RE: **PUBLIC** Comments of the Minnesota Department of Commerce
Docket No. E002/M-25-142

In the Matter of Xcel Energy's 2025 Integrated Distribution Plan.

Xcel Energy's (Xcel or the Company) Integrated Distribution Plan (IDP) was filed on October 31, 2025. Xcel's Transportation Electrification Plan was filed concurrently.

The Department recommends the Commission accept Xcel's IDP with additional requirements and is available to answer any questions the Minnesota Public Utilities Commission may have.

Figure 4: Xcel Presentation of Mandatory VS Discretionary Spending

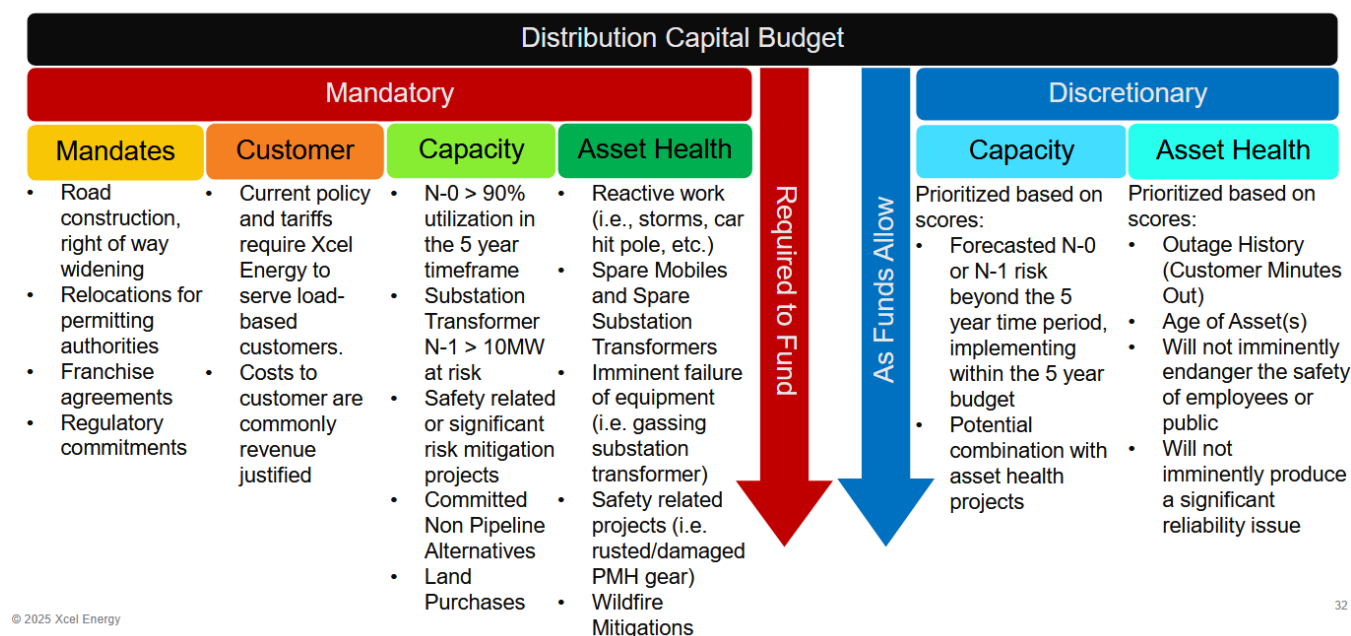
Xcel may counter that large portions of its system planning are not discretionary (Figure 4), which implies that these projects do not require optimization. While the Department does not question the validity of some mandatory spending shown in Figure 4, the Department disagrees on Xcel's use of the term "mandatory." Upstream decision making before budgeting, such as decisions made in forecasting, capacity planning limits, the benefits of reliability, and wildfire mitigations all involve judgment and choice. As the Department will demonstrate in these comments, there is a strong need to evaluate whether Xcel's system planning decisions are in the public interest.

Figure 6: Comparison of Actual Feeder Capacity to Xcel's N-0 Capacity Planning Standard

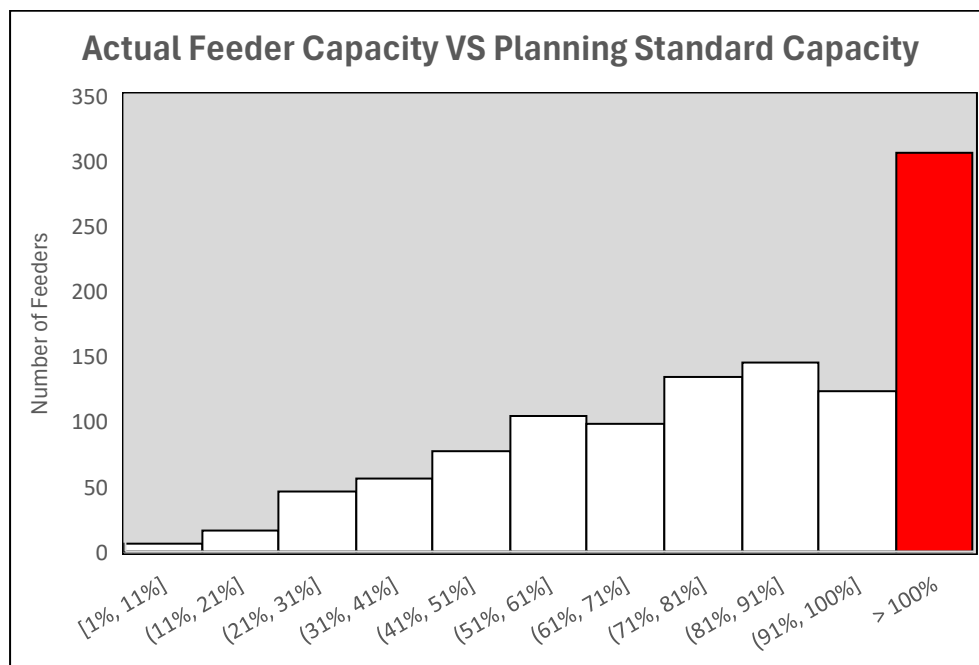
While Xcel may argue that these planning standards cannot be modified, these assertions are easily refuted by Xcel's own data. Figure 6 shows that 27 percent of Xcel's existing feeders are currently exceeding Xcel's planning standard, which indicates that the Company decided to not fully enforce its own planning standards.

Figure 17: Number of Feeders That Exceed the 75% Capacity Planning Standard: 2019–2029

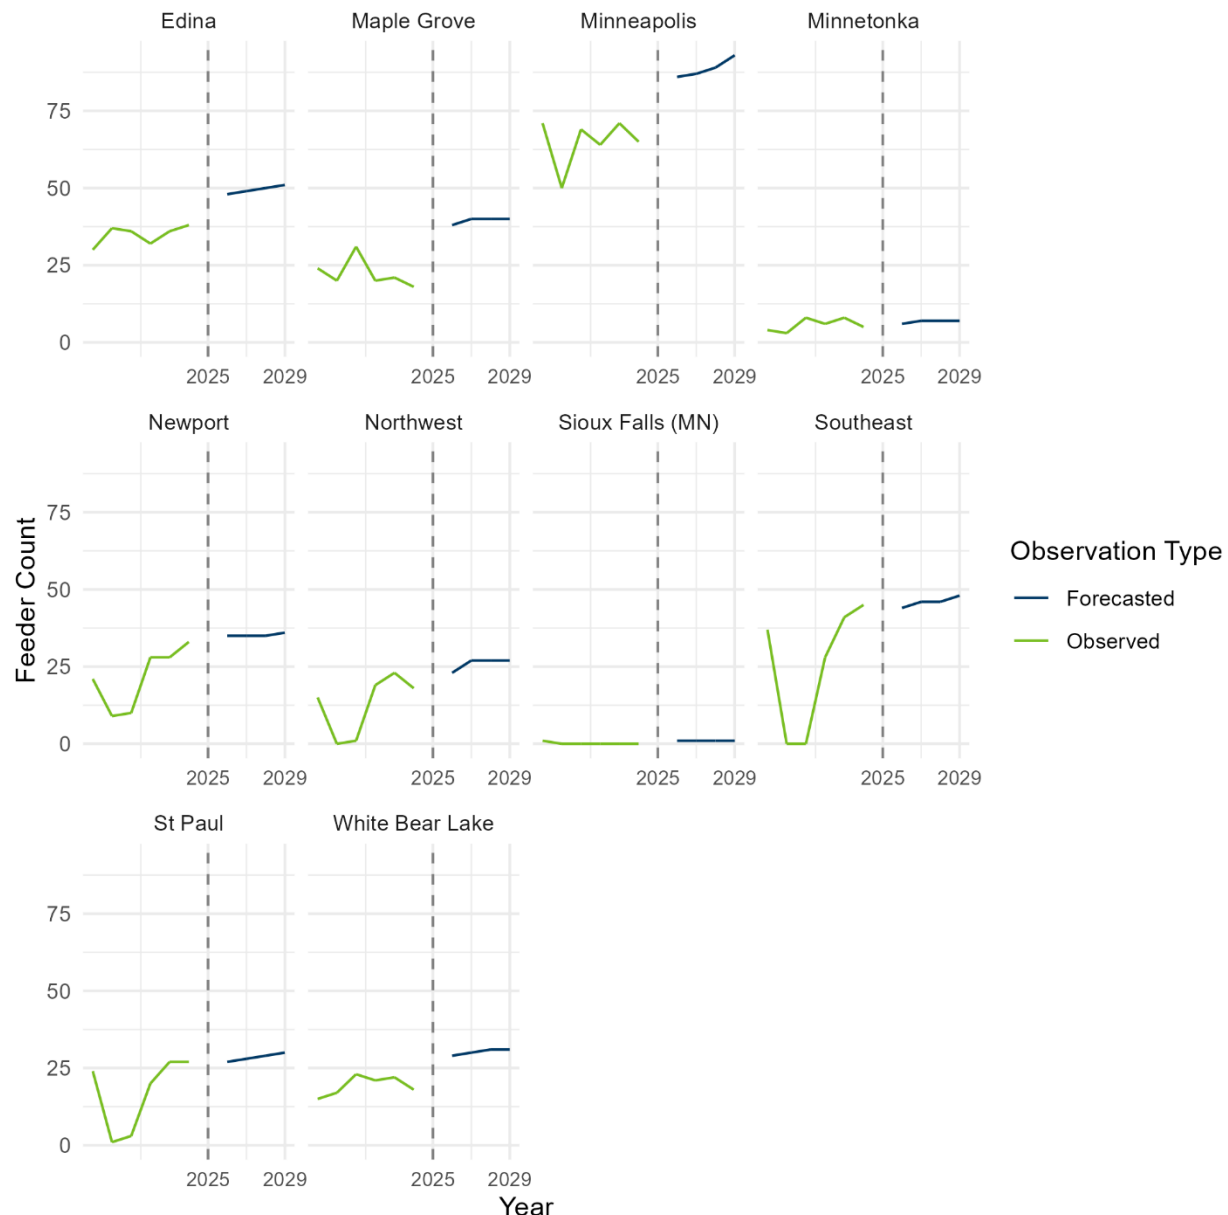
Xcel identifies the need to upgrade feeder capacity as a major driver of distribution spending. To better understand this driver, the Department requested data on feeder utilization. In response to IR 8, Xcel provides counts of feeders operating above 50 percent and 75 percent of their planning limits. Figure 17 summarizes the number of feeders exceeding 75 percent of planning capacity over time,

disaggregated by Planning Division. This figure indicates that capacity constraints are not evenly distributed across the system; certain PDs consistently exhibit higher numbers of heavily loaded feeders.

These patterns raise important questions about the underlying causes of forecasted rise in feeder congestion and whether capital investments are efficient. While most planning divisions show observable trends in Figure 17, Edina, Maple Grove, Minneapolis, and White Bear Lake all show visible

Figure 19: Projected Increase in Heating Load by Planning Division

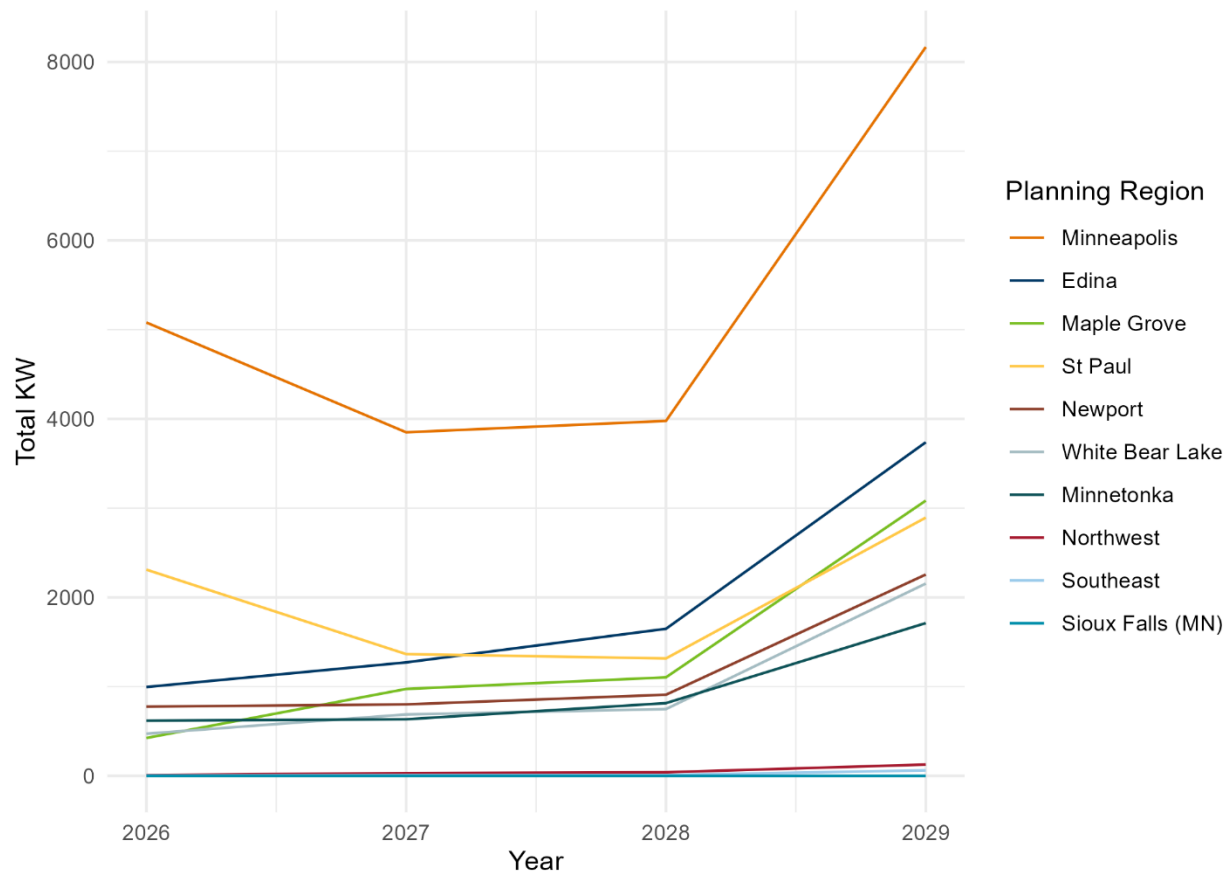
To better understand these projected increases, the Department reviewed the individual components contributing to peak load growth, as provided by the Company in response to IR 11 and summarized in Figures 19–21. This breakdown indicates that electrification-related loads—particularly electric space heating and electric vehicle (EV) charging—are major contributors to projected peak demand in several Planning Divisions.

For example, in Minneapolis, forecasted heating-related peak load is projected to approximately double within a two-year period. Similarly, EV-related peak load increases sharply in multiple PDs over the forecast horizon. While electrification is an expected long-term trend, the magnitude and timing of these increases raise questions about the underlying assumptions driving the Company's forecasts.

Figure 20: Projected Increase in EV Load by Planning Division

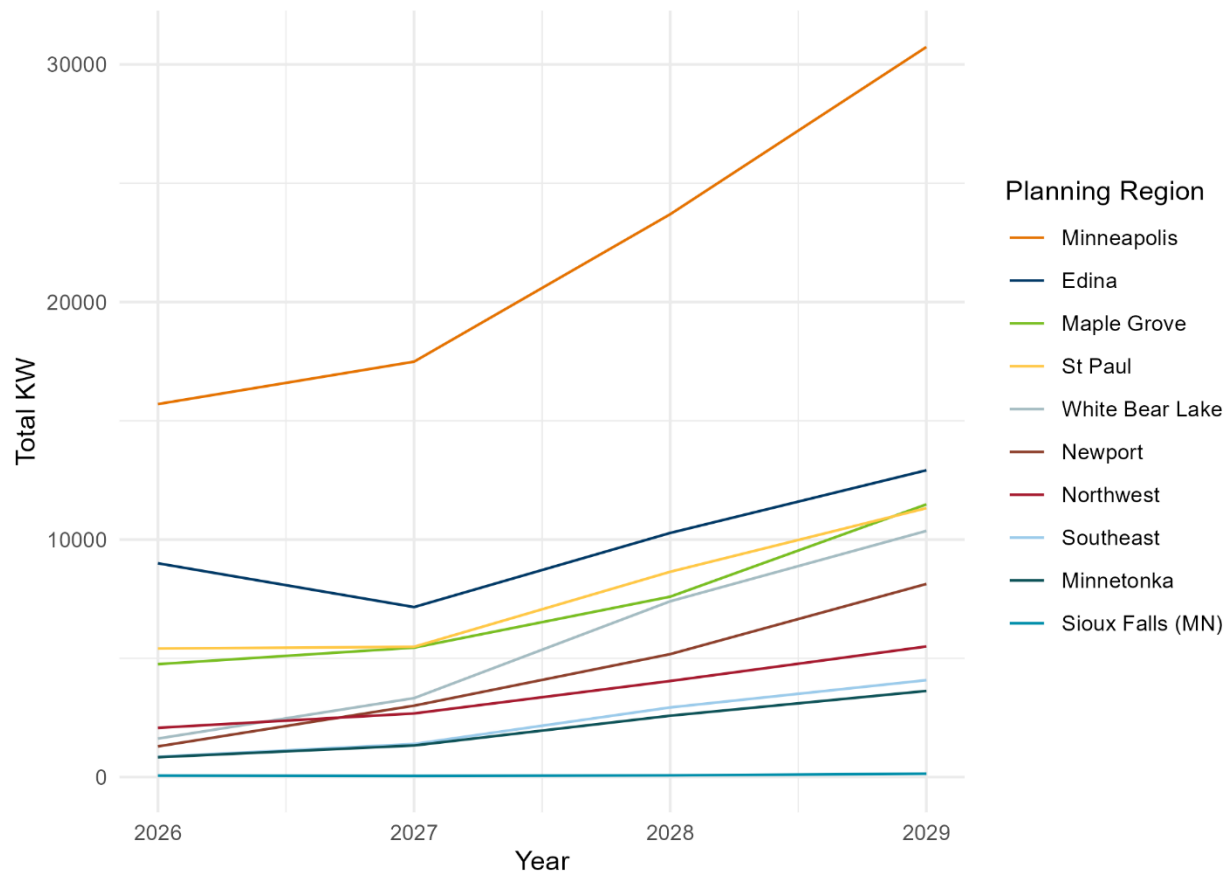
In particular, the Department is concerned that projected peak load growth may be driven by optimistic assumptions regarding the pace of technology adoption rather than by empirically observed trends. Recent historical data on heat pump installations, EV adoption, and customer load shapes generally show more gradual uptake, influenced by factors such as equipment costs, building stock turnover, consumer preferences, and infrastructure constraints.⁷² The Company's forecasts appear to assume rapid and widespread adoption over a short period without clearly demonstrating that such adoption rates are consistent with observed customer behavior in each Planning Division.

Figure 24: Actual Feeder Loading Compared to Rated Capacity

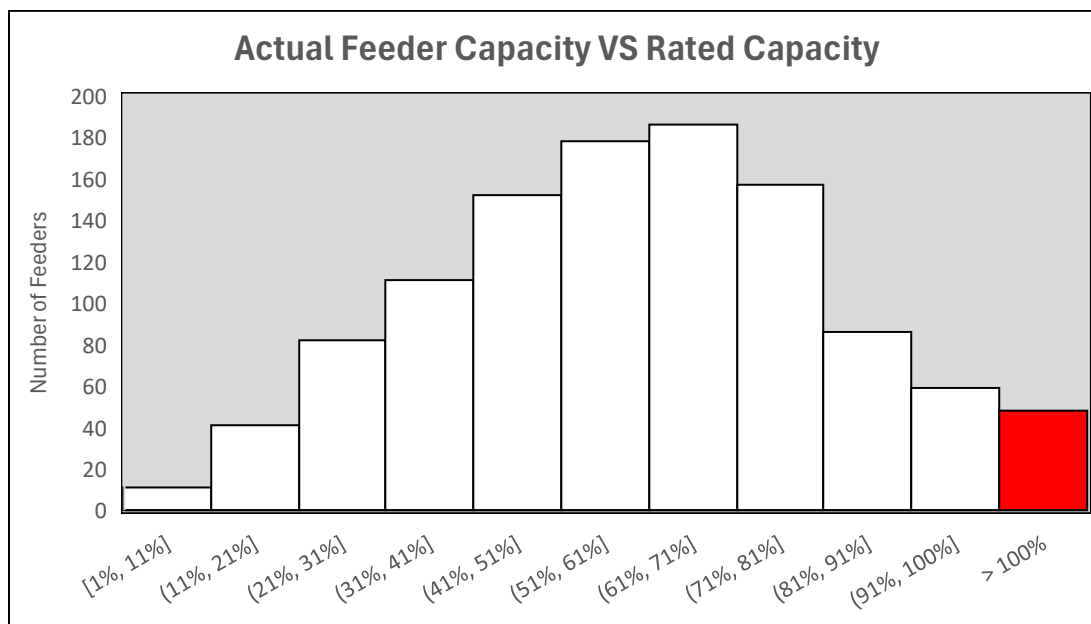
Xcel's feeder capacity data reflects a similar pattern, where 3.2% of feeders are currently overloaded, as shown in Figure 24.

Figure 26: Xcel Line Utilization by Planning Division (Avg Energy Use / Rated Capacity)

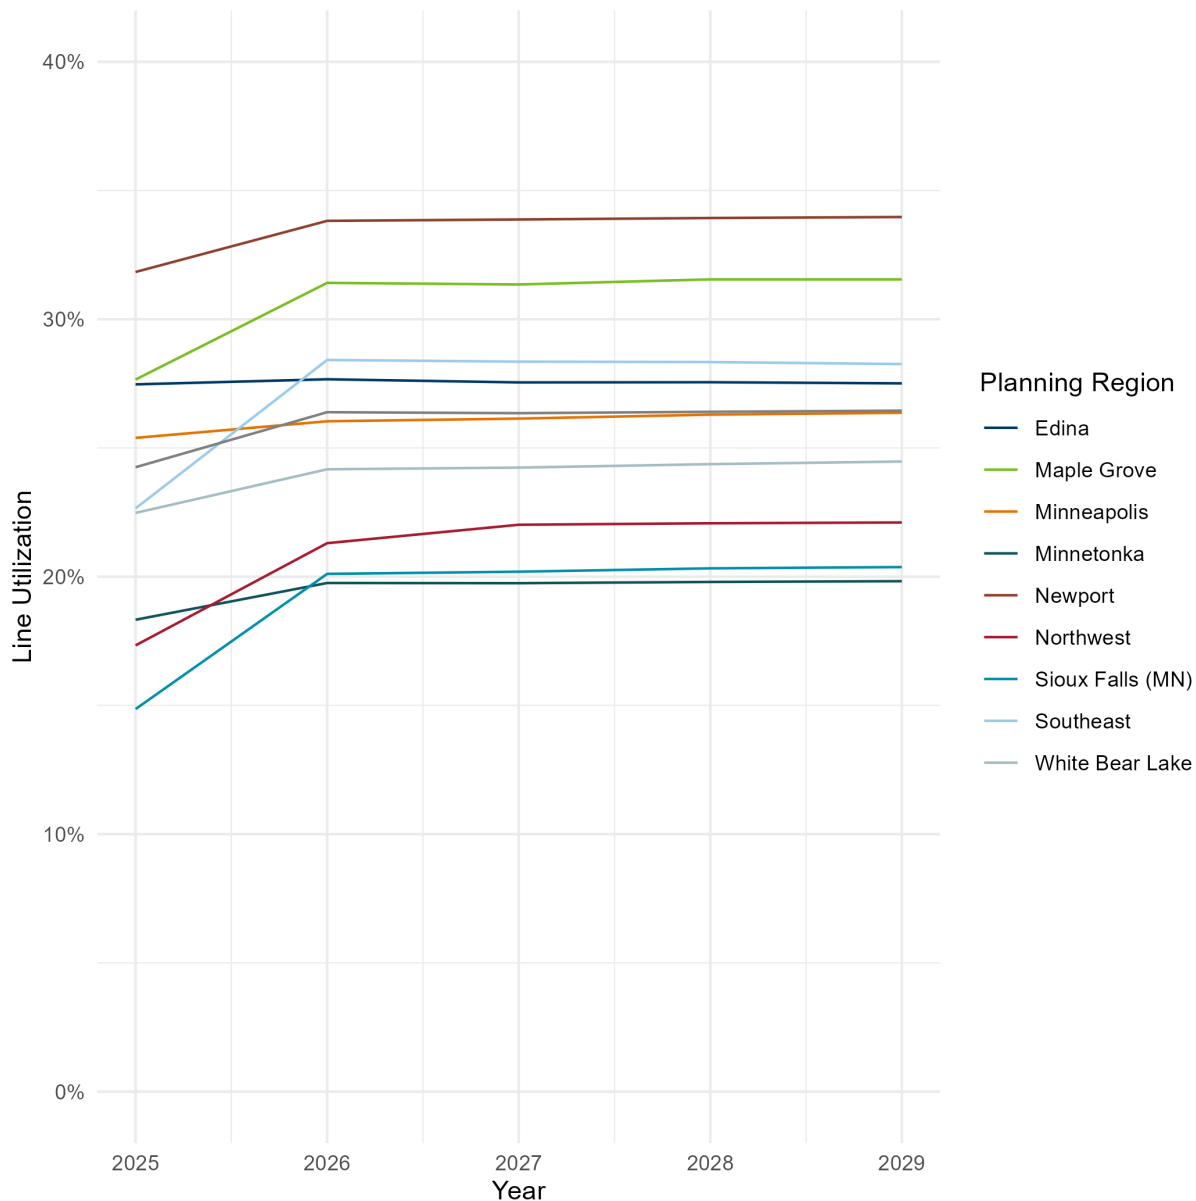
[TRADE SECRET DATA HAS BEEN EXCISED] Generally, most feeders in Xcel's territory have ample capacity for switching, as demonstrated by Xcel's line utilization data from IR 13 shown in Figure 26.⁹¹

The probability of rare N-1 peak day outages and their consequences must be weighed against Xcel's planned budget to mitigate these risks. Xcel plans to spend \$293 million to mitigate N-1 risks listed in Attachment E,⁹² which represents less than half of Xcel's 5-year capacity budget.⁹³ With an estimated annual N-1 risk capacity budget of \$141 million,⁹⁴ it is important to evaluate whether these costs are

Figure 29: Relationship between Overhead Line Miles and Customer Minutes Out for Feeders in Xcel's Service Territory.

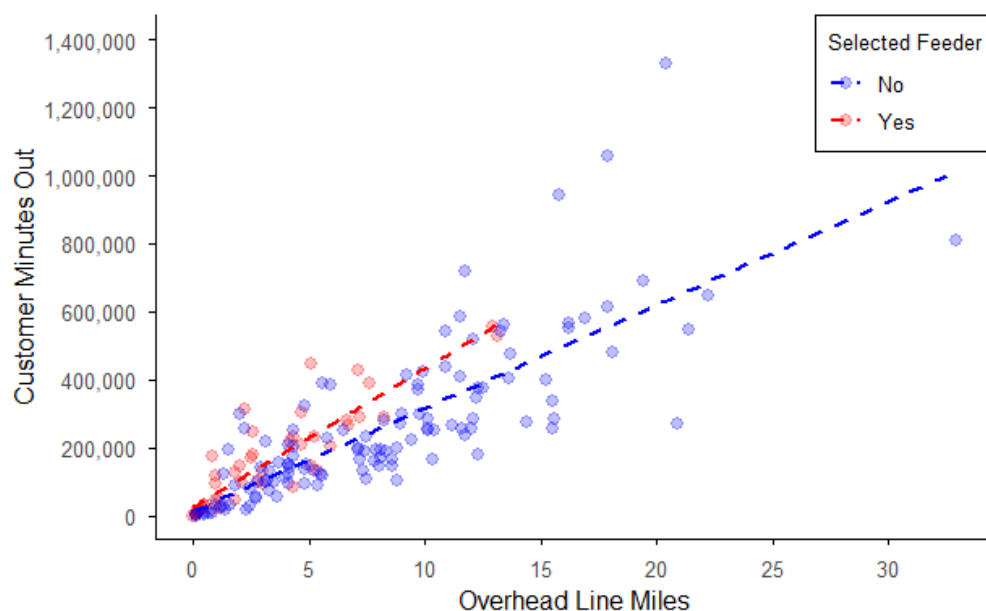
Figure 29 offers empirical support for the Targeted Undergrounding Plan through the demonstration of a clear correlation between overhead line miles and customer minutes out. The linear relationship confirms that feeders with extensive overhead infrastructure experience more significant service

interruptions, which provides justification for the strategic relocation of high-risk segments to improve system resilience and reduce total outage durations. More importantly, the higher rate of accumulation for feeders selected for undergrounding (Selected Feeders 'Yes'), represented by a steeper slope, demonstrates that the First Targeting Method Scenario prioritized feeders with the highest outage impact relative to the overhead line miles. By targeting these higher-value feeders, the method focuses resources on the specific assets where the reliability gains per undergrounded mile are most significant. While the linear relationship provides a high-level physical justification, it fails to account for the diminishing returns of undergrounding in areas where outages are driven by equipment failure or lightning rather than trees and wind.
